REVIEWER NOTES

PROPOSED IMPROVEMENT
BRIDGE PROJECT

ROUTE NO : VT 105A, MINOR COLLECTOR BRIDGE NO : 3

PROJECT NAME : RICHFORD - SUTTON, PQ
PROJECT NUMBER : BHF 0814(1)

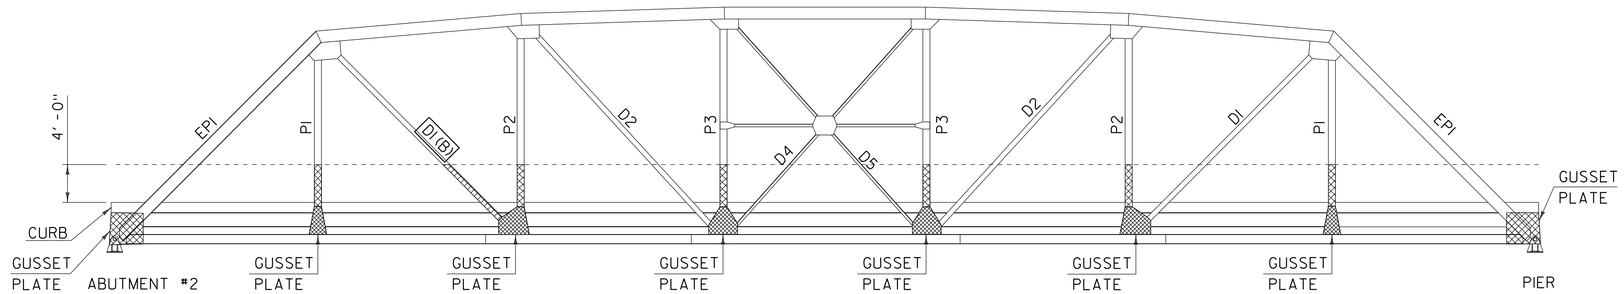
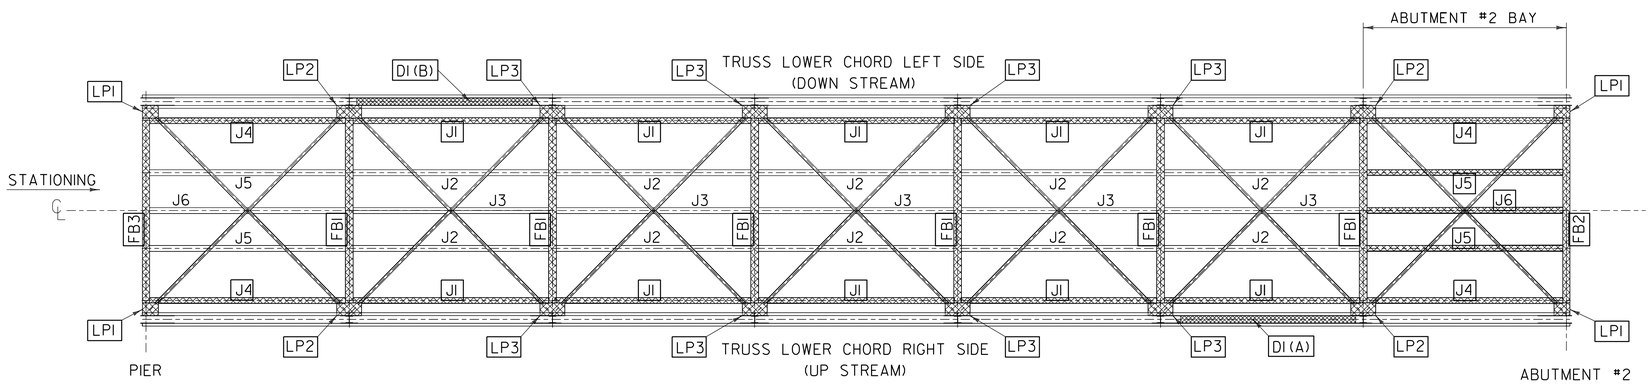
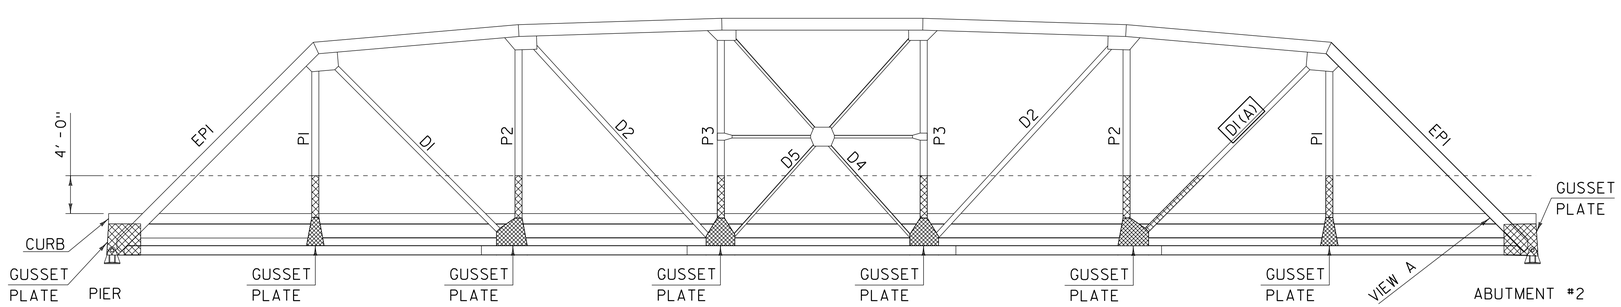
1. FINAL HYDRAULICS HAS BEEN REQUESTED BUT NOT INCLUDED IN THIS PLAN SET.
2. FINAL DETERMINATION OF SALVAGED VS REPLACED TRUSS COMPONENTS WILL REQUIRE AN IN-DEPTH INSPECTION OF THE ENTIRE TRUSS SPAN DURING THE FINAL PLAN PHASE.
3. IT IS ANTICIPATED THAT RIGHT-OF-WAY ACQUISITION WILL NOT BE NECESSARY FOR THIS PROJECT.
4. IT IS ANTICIPATED THAT UTILITY RELOCATION WILL NOT BE NEEDED.
5. BRIDGE WILL BE CLOSED DURING CONSTRUCTION. A SIGNED DETOUR FOR THE PROJECT WILL UTILIZE VT 105 TO VT 139 TO THE BORDER CROSSING IN EAST RICHFORD, VT.
6. THE UNITED STATES BORDER CROSSING STATION HAS A TRAFFIC SIGNAL AS WELL AS DETECTION EQUIPMENT BURIED IN THE PAVEMENT AND GROUND. VTRANS WILL NEED TO COORDINATE TO EITHER REPLACE WITH THE PROPER EQUIPMENT, LEAVE IT ALONE, OR HAVE BORDER CROSSING REMOVE PRIOR TO CONSTRUCTION.
